Access Compliance Report

Public Rights-of-Way

Intersection ID: 10100	Main Street: ASHLEY_RD	Cross Street: FREEDOM_DR	Location: S
ADA ID: 504C19ADC347	Ramp Type: Perp	Initial Pass/Fail: Fail	Overall Compliance: No
		Severity Score: 10

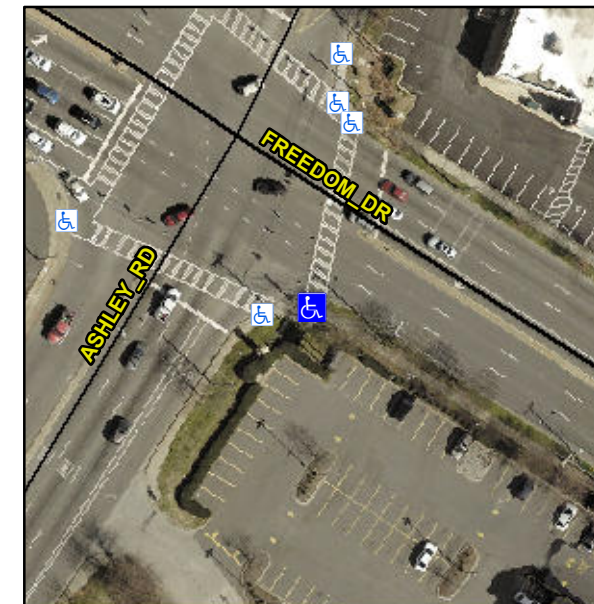
R304.5.1

Compliance	Description	Data	Compliance	Description	Data
N/A	Ramp Length (in)	51.5	Yes	Ramp Slope (%)	5.1
No	Ramp Width (in)	47.5	Yes	Ramp XSlope (%)	2.1
N/A	Flare Type LT	N/A	N/A	Flare Type RT	N/A
N/A	Flare Slope LT (%)	N/A	N/A	Flare Slope RT (%)	N/A
N/A	Flare Traversable LT?	N/A	N/A	Flare Traversable RT?	N/A
N/A	Landing Length (in)	N/A	N/A	DWS Provided?	N/A
N/A	Landing Width (in)	N/A	N/A	DWS Contrast?	N/A
N/A	Landing Slope (%)	N/A	N/A	DWS Length (in)	N/A
N/A	Landing X Slope (%)	N/A	N/A	DWS Full Width?	N/A
N/A	Landing Curb? (Y/N)	N/A	N/A	DWS Offset (in)	N/A
N/A	Shared Landing?	N/A			
N/A	Gutter Ponding?	Yes	N/A	Gutter Slope (%)	N/A
N/A	Gutter Lip Ht (in)	N/A	N/A	Gutter X Slope (%)	N/A
N/A	Painted X Walk1?	Yes	N/A	Painted X Walk2?	N/A
	X Walk 1 Direction	To NE		X Walk 2 Direction	N/A
N/A	X Walk 1 Width (in)	111.0	N/A	X Walk 2 Width (in)	N/A
	X Walk 1 Slope (%)	4.7		X Walk 2 Slope (%)	N/A
	X Walk 1 X Slope (%)	2.6		X Walk 2 X Slope (%)	N/A

Remove & Replace Entire Ramp.
